SERVICE No. 192 BULLETIN

Piper Aircraft Corporation

SUBJECT: Throttle Limit Switch Bracket

MODELS AFFECTED: PA-24 and PA-24-250 Comanches

REVISED INSTALLATION OF THROTTLE LIMIT SWITCH BRACKET 21246-00

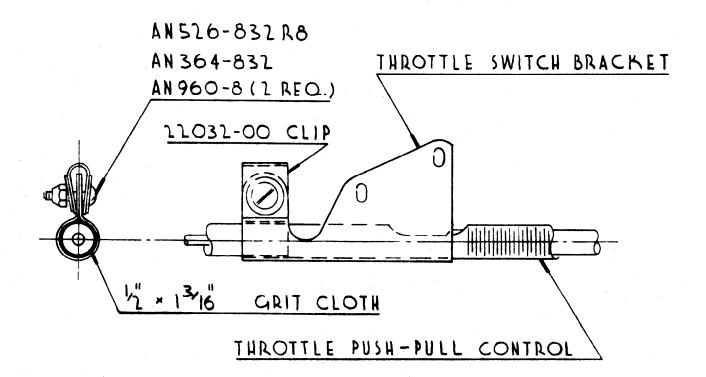
The Service Department has been advised that a movement of the throttle switch bracket during operating conditions has been noted. The movement of this bracket will vary the timing of the landing gear warning horn. To insure a more positive installation of the throttle switch, a piece of grit cloth and a clip shall be installed as per the sketch on the reverse side of this bulletin.
